April 4, 2024
Planning Commission
Regular Meeting
Information Packet

Discussion of the proposed Preliminary
Final plan for the Anderson Ranch
subdivision Phase 4E, located at
approximately Silver Spur Rd (East of
Anderson Ranch Phase 3).

Planning Staff Explanation and Recommendation: Discussion only for Anderson Ranch Phase 4E. Please note that the plat was labeled as a Preliminary Plat, and was noticed as such. However, it is a Final Plat, and has been reviewed as such.

ANDERSON RANCH PHASE 4E

Final PRELIMINARY PLAT

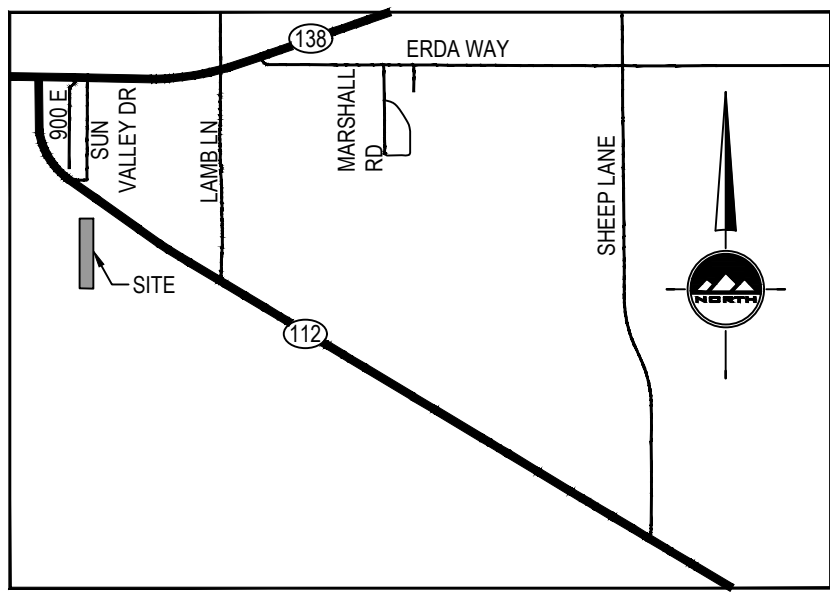
Provide a summary of total project acreage, total acreage in lots, total number of units, total acreage of open space or other dedicated parcels, and total acreage in roads and lane miles of road.

Provide Sight Triangle diagram
on all corner Lots.

Appears there is not detention pond on the plat, provide a note explaining how detention is handled.

Provide physical description
such as "Brass Cap"

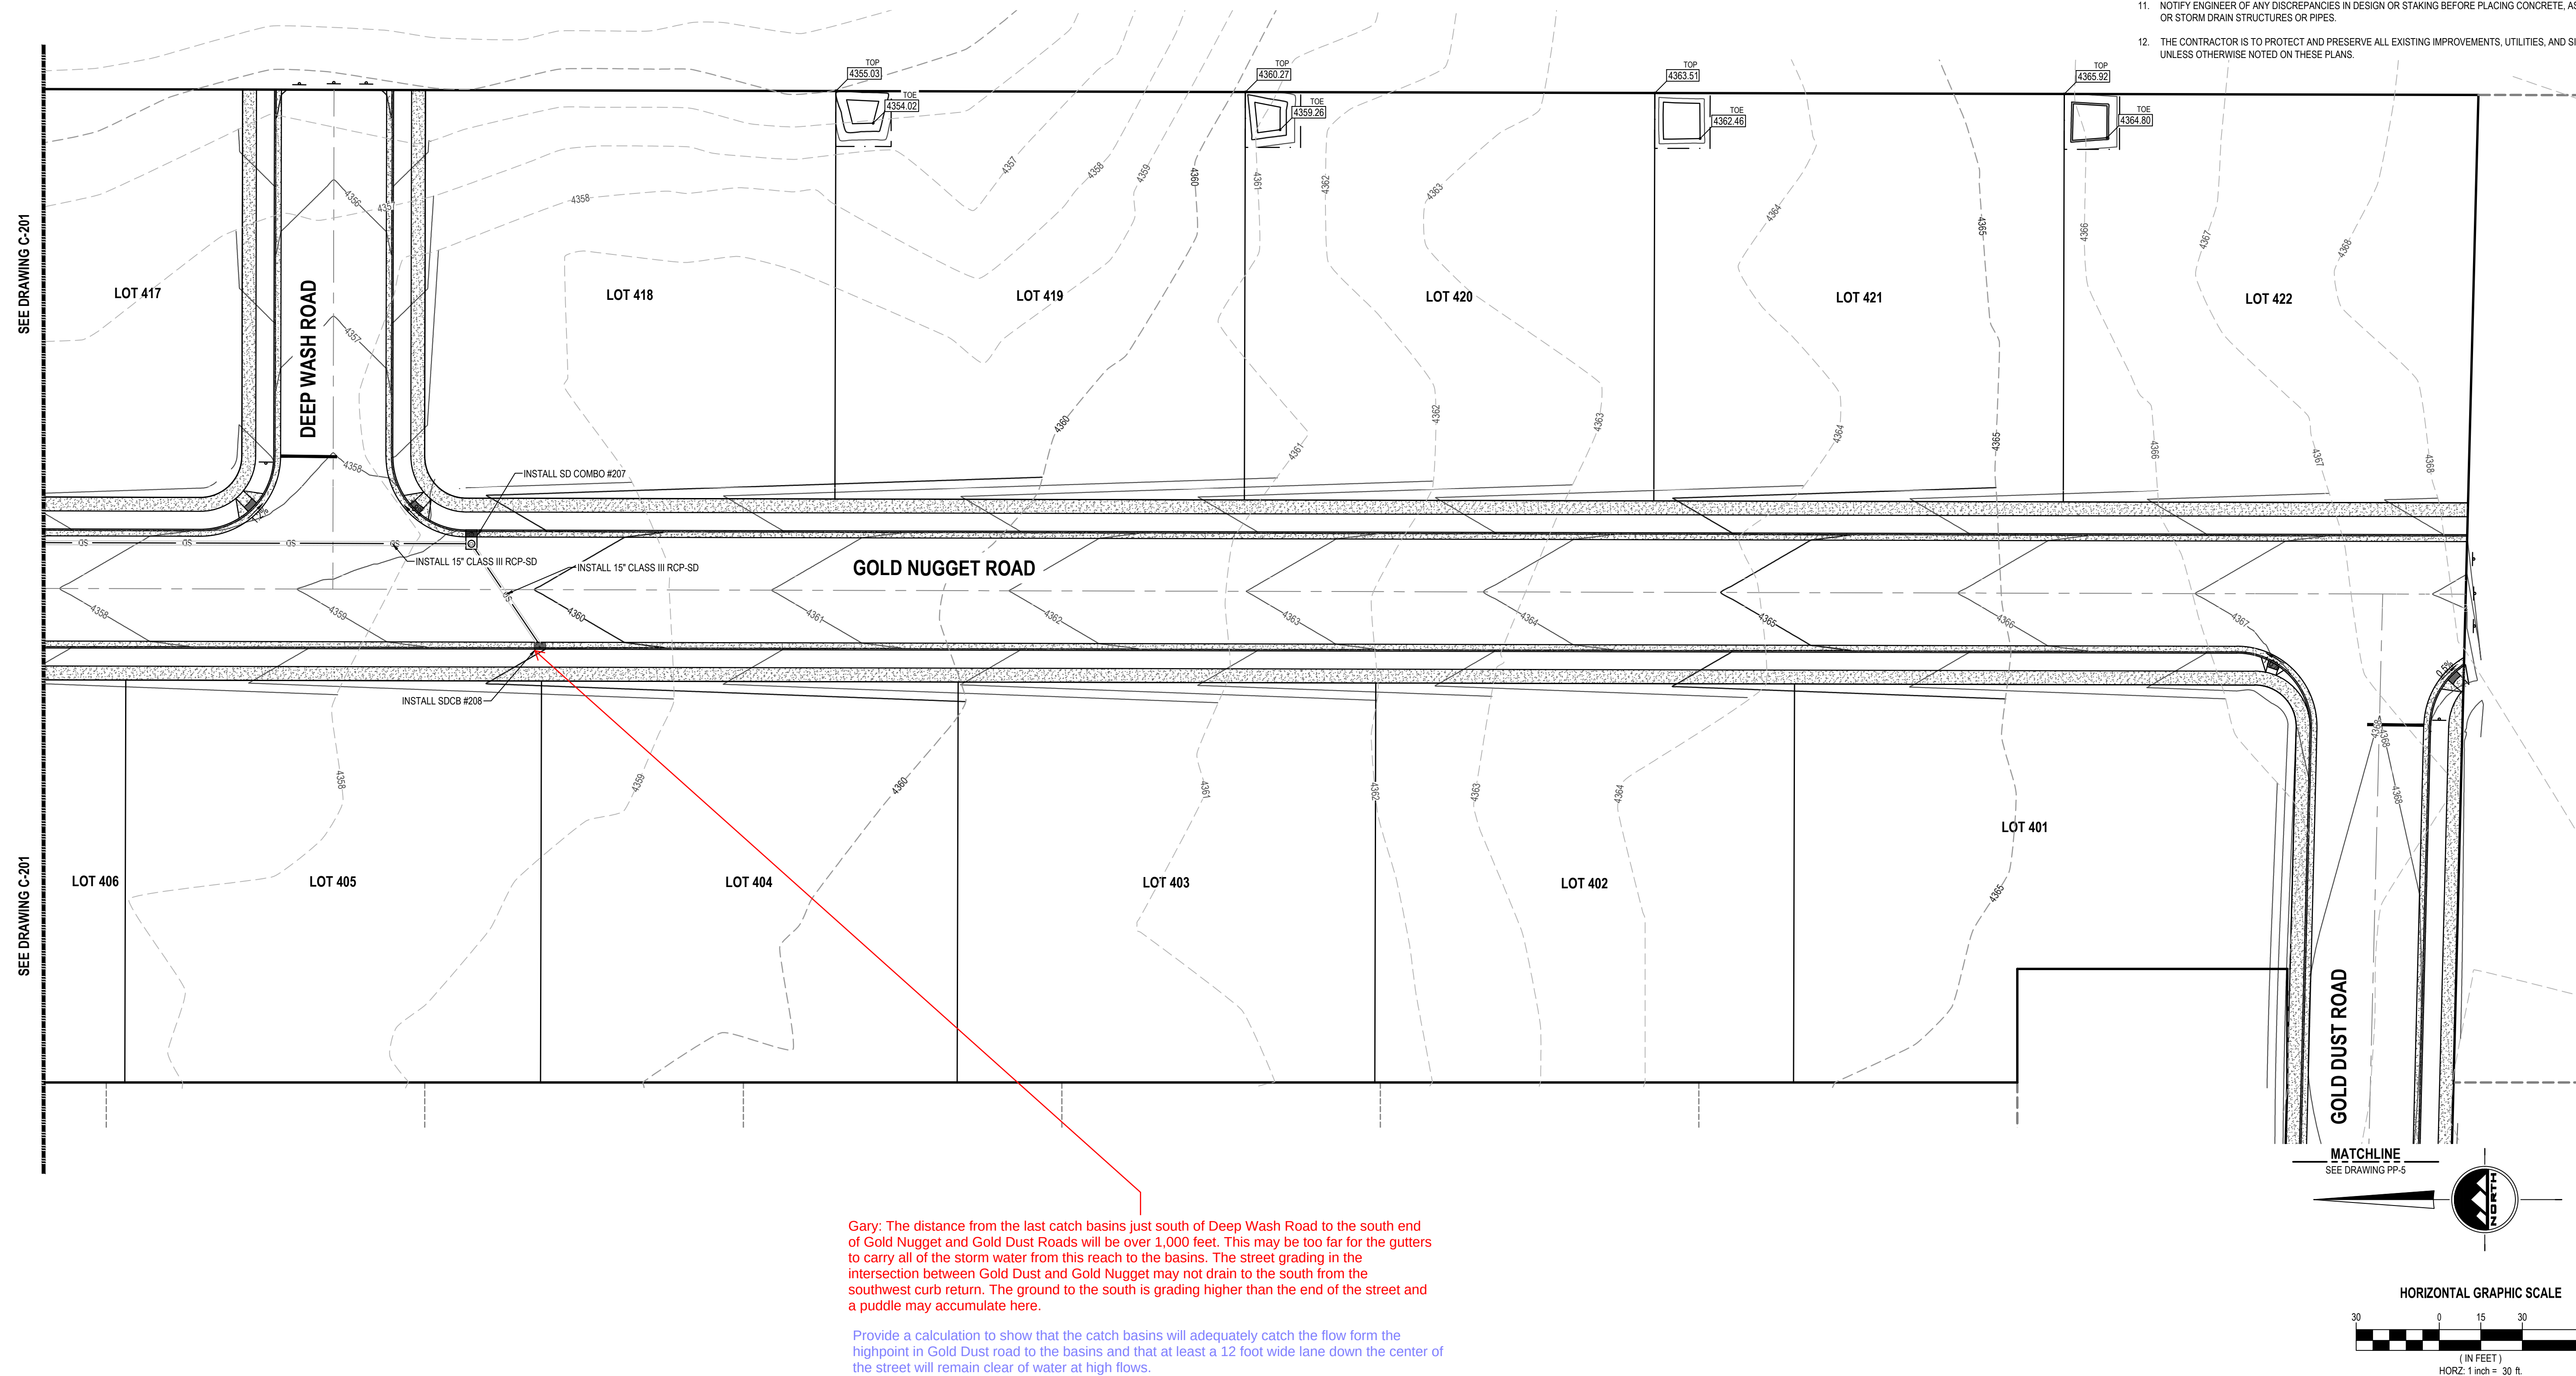
Gary: The distance from the last catch basins just south of Deep Wash Road to the south end of Gold Nugget and Gold Dust Roads will be over 1,000 feet. This may be too far for the gutters to carry all of the storm water from this reach to the basins. The street grading in the intersection between Gold Dust and Gold Nugget may not drain to the south from the southwest curb return. The ground to the south is grading higher than the end of the street and a puddle may accumulate here.

Provide a calculation to show that the catch basins will adequately catch the flow from the highpoint in Gold Dust road to the basins and that at least a 12 foot wide lane down the center of the street will remain clear of water at high flows.

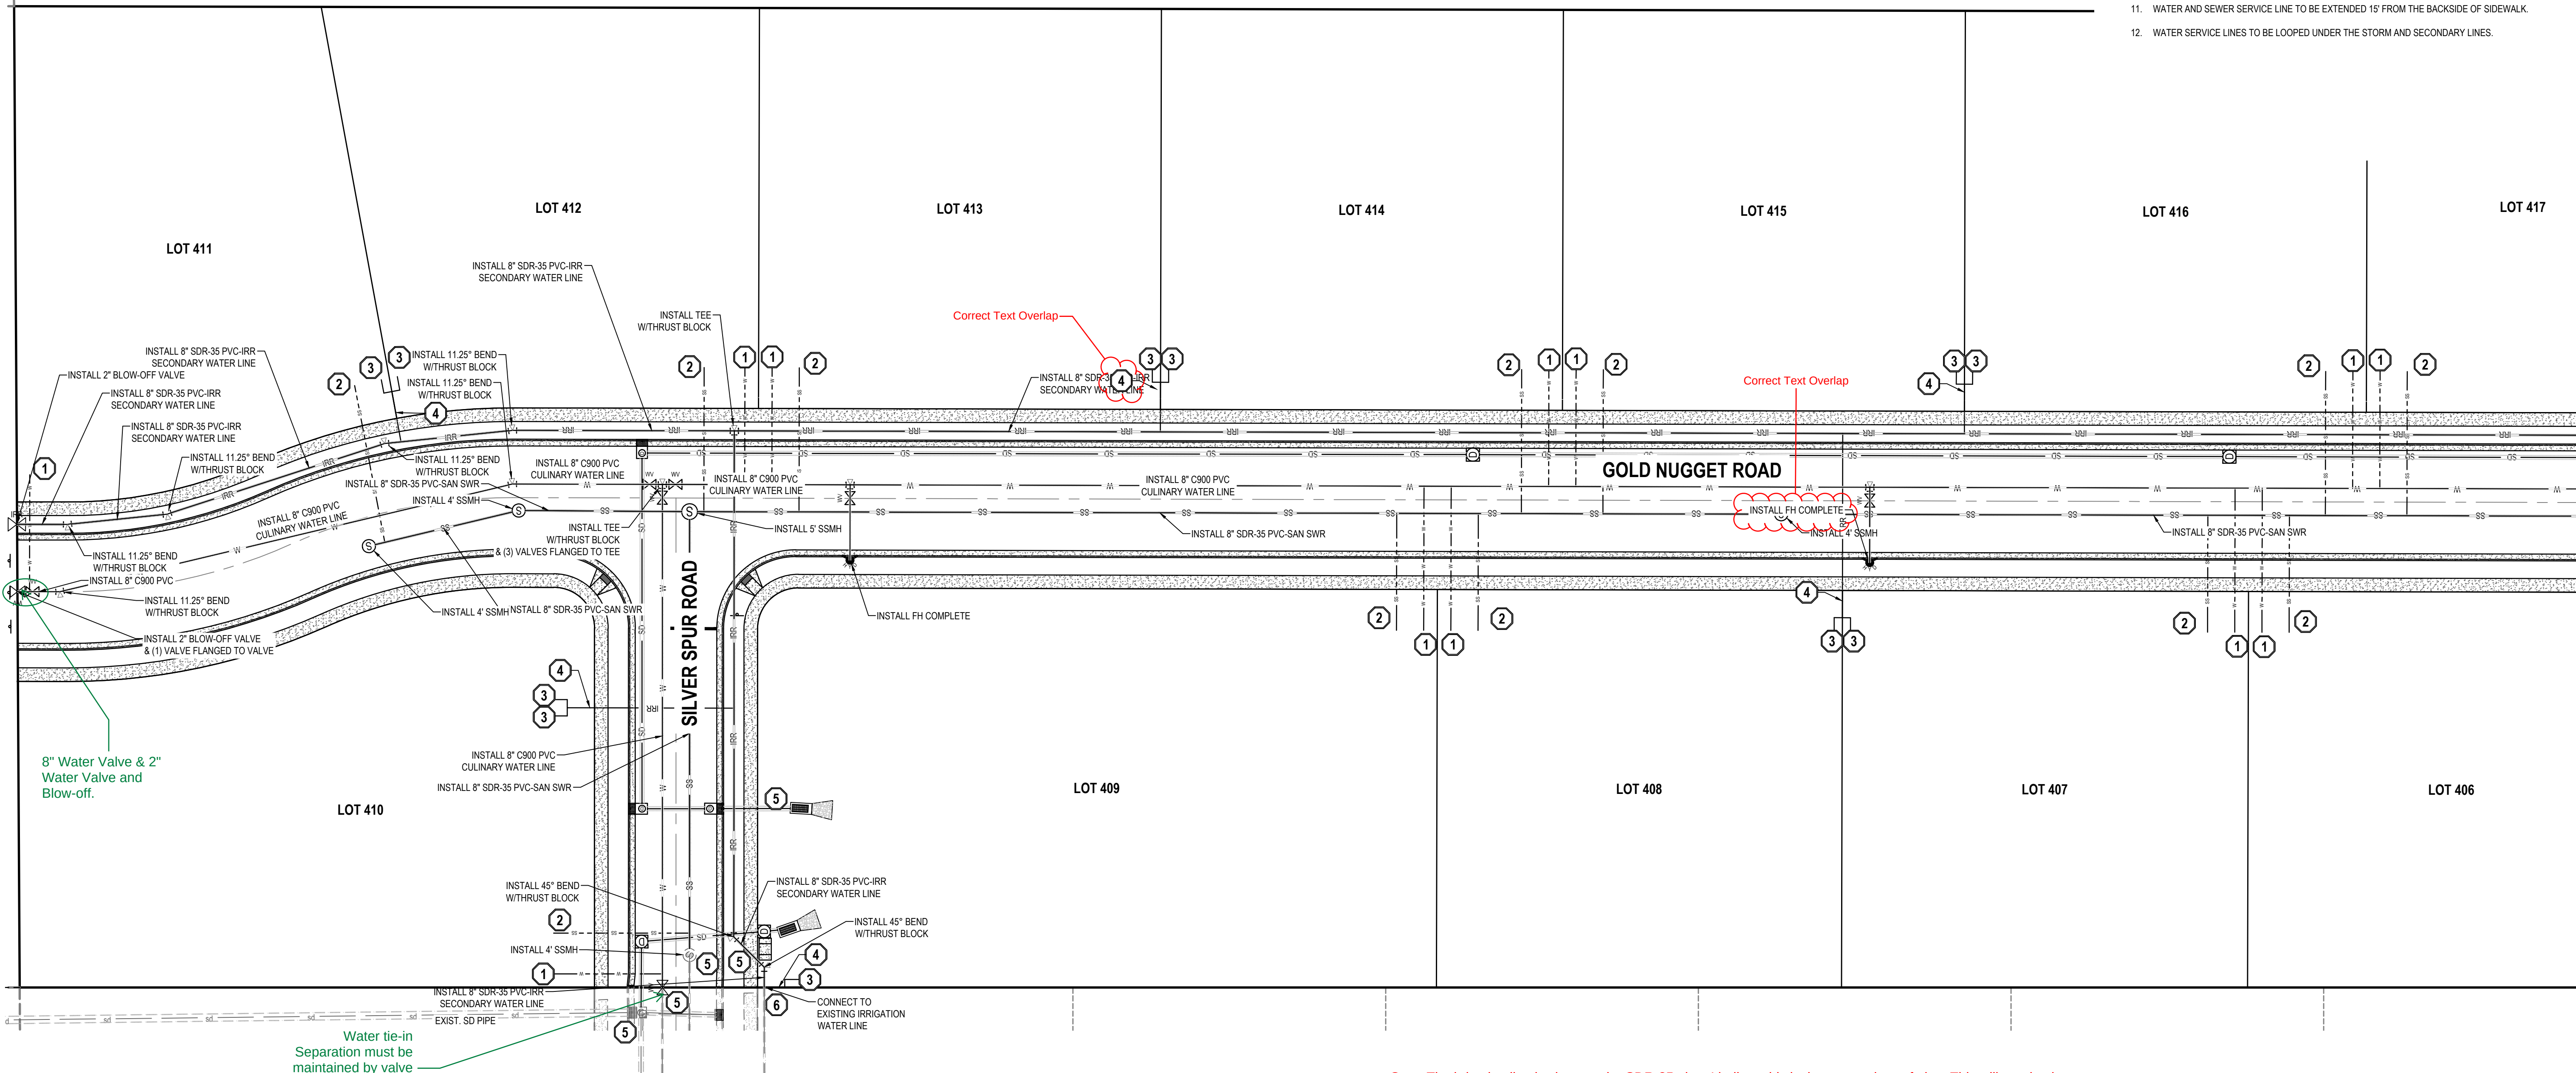
Gary: The irrigation line is shown to be SDR-35 pipe. I believe this is the wrong class of pipe. This will need to be higher rated water pipe.

Sewer lateral shall be installed down hill flow of sewer main.

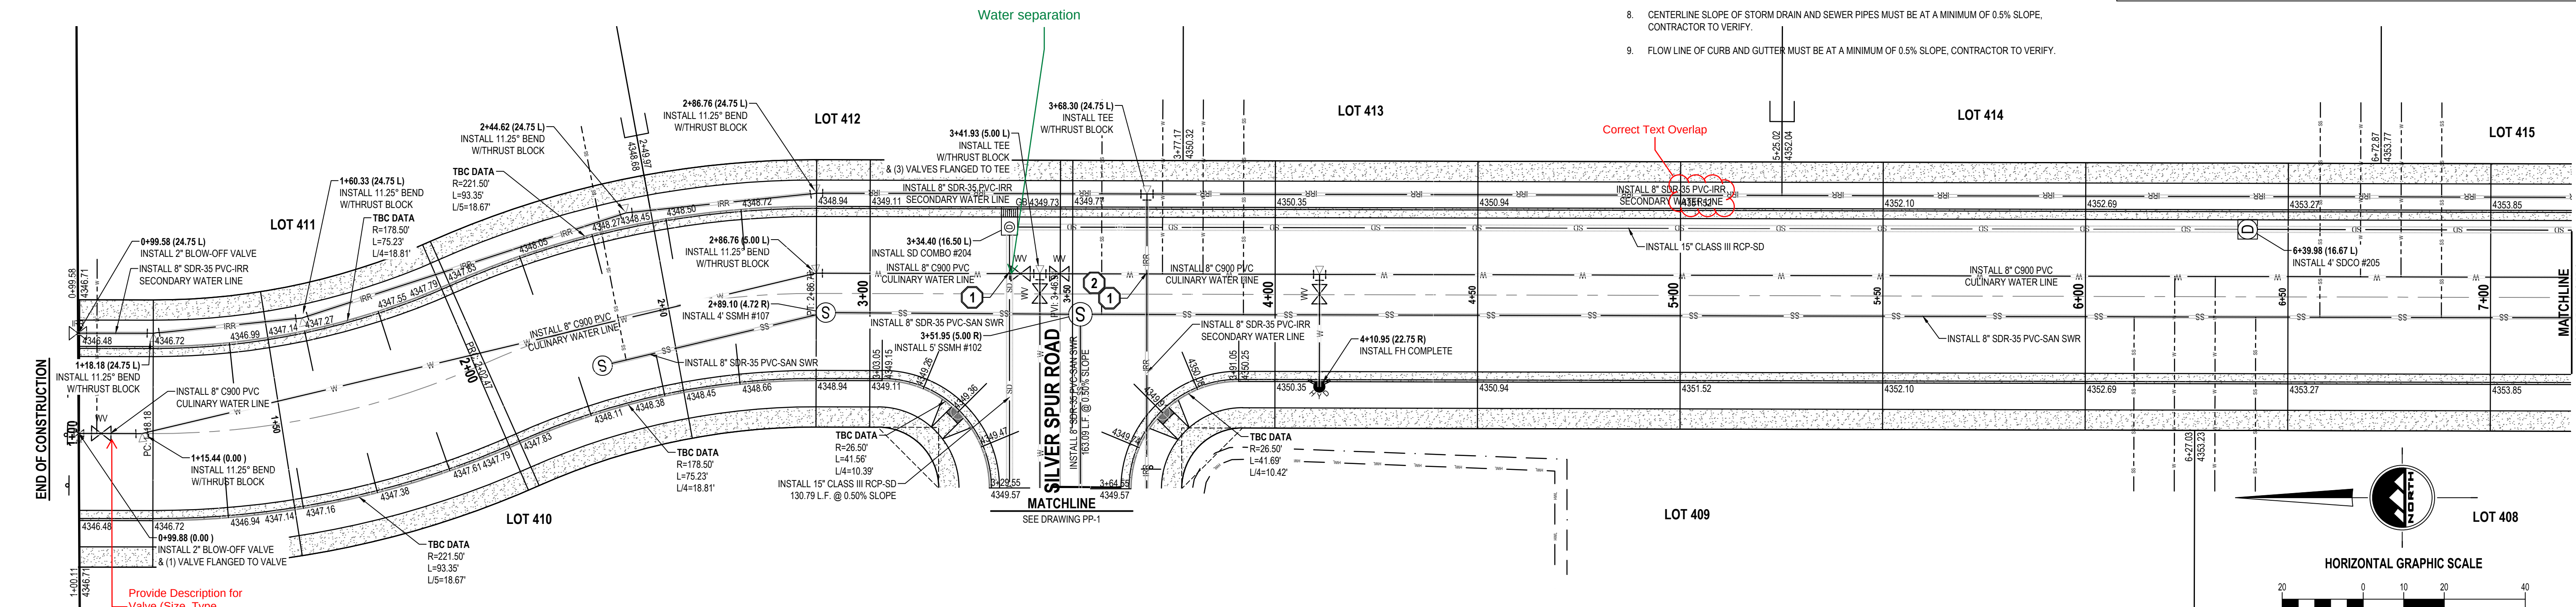
We need to have further discussion about this as the sewer line slopes are at
minimum grades and the sewer elevation cannot be lowered.

Gary: Where the culinary water services cross the storm drain alignment the service
pipe will need to be looped under the storm line with a minimum of 18" of separation.

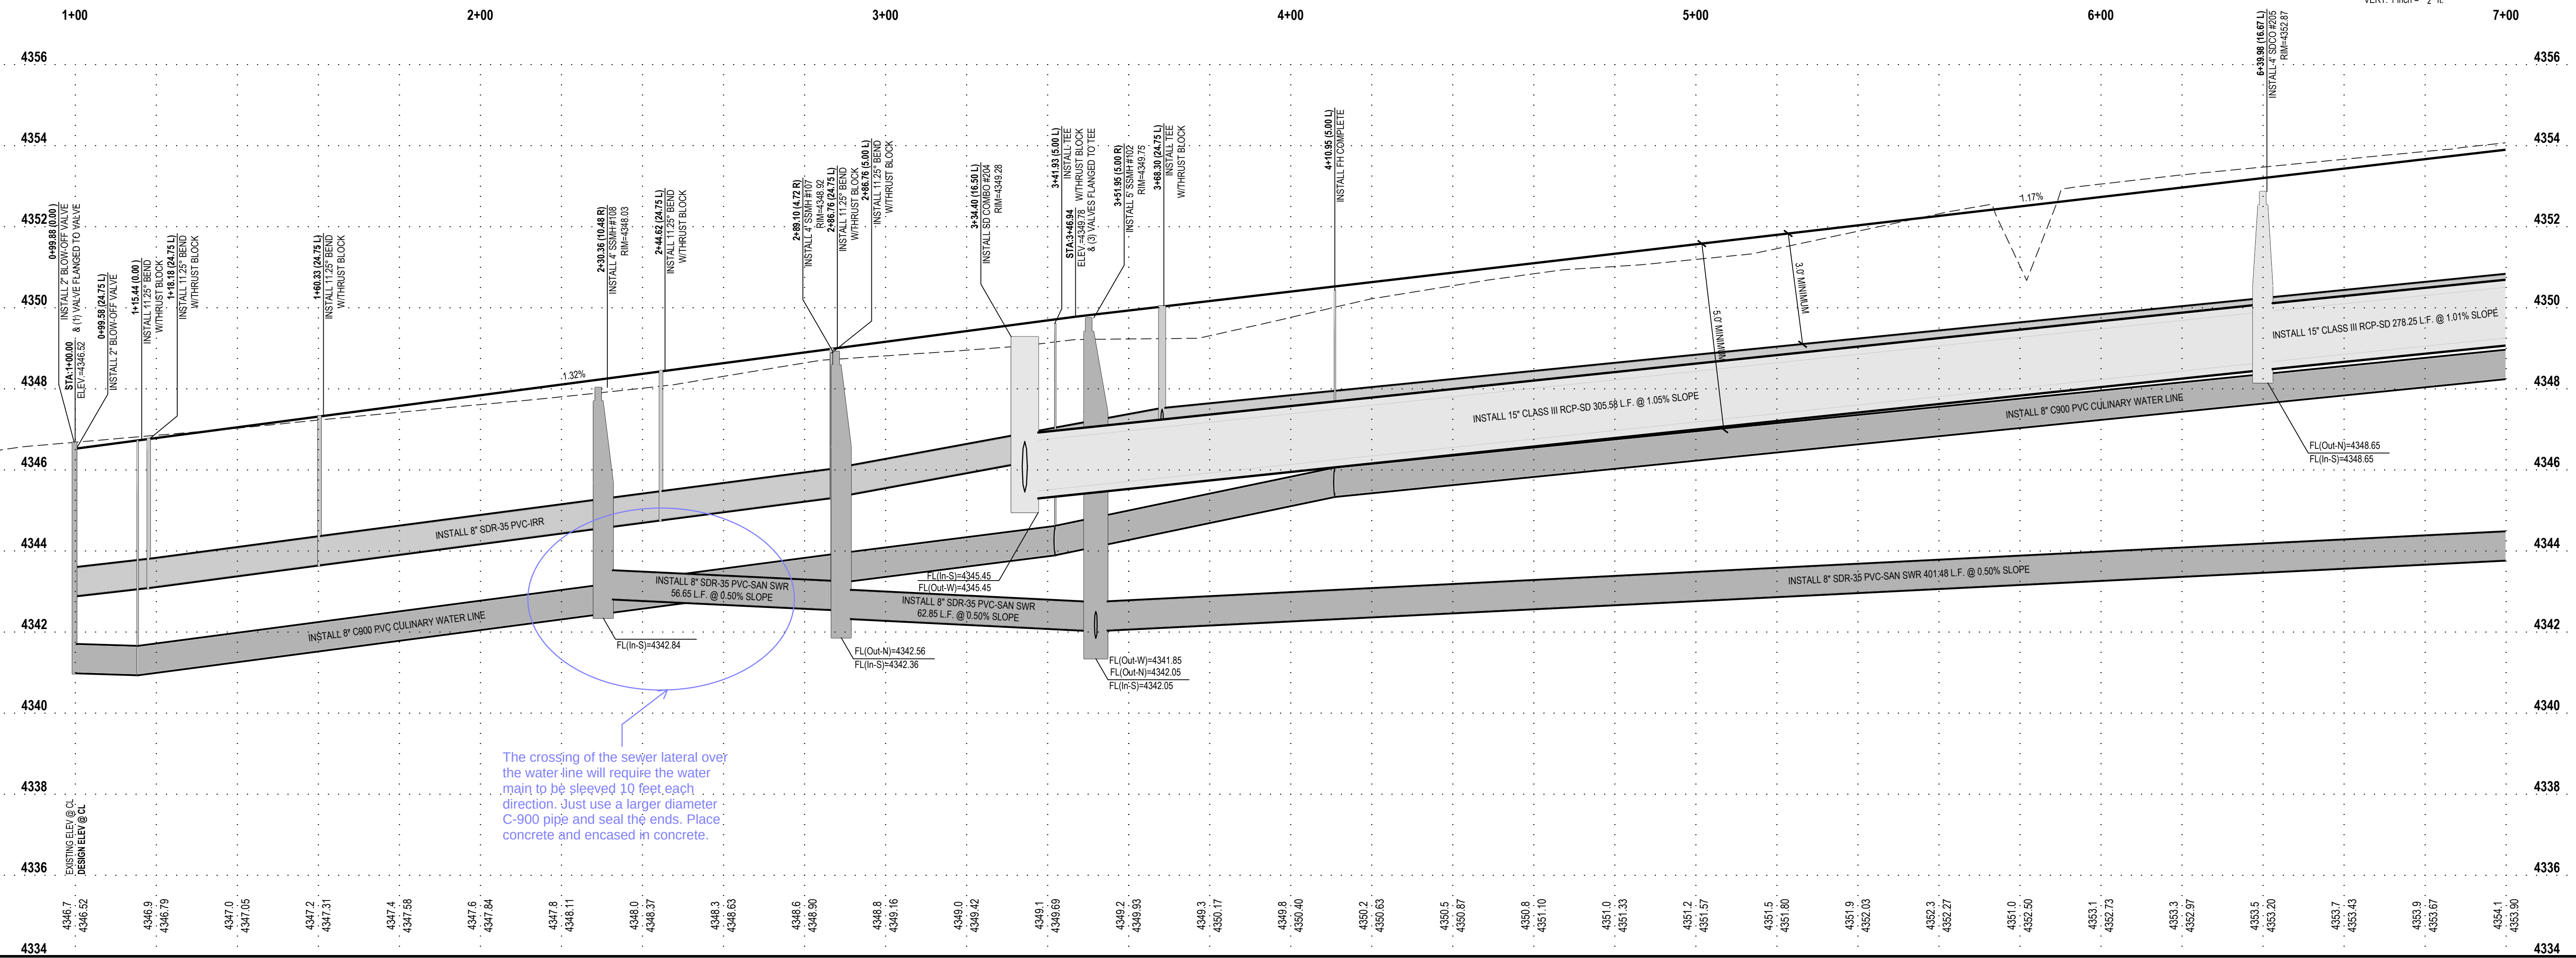
The crossing of the sewer lateral over
the water line will require the water
main to be sleeved 10 feet each
direction. Just use a larger diameter
C-900 pipe and seal the ends. Place
concrete and encased in concrete.
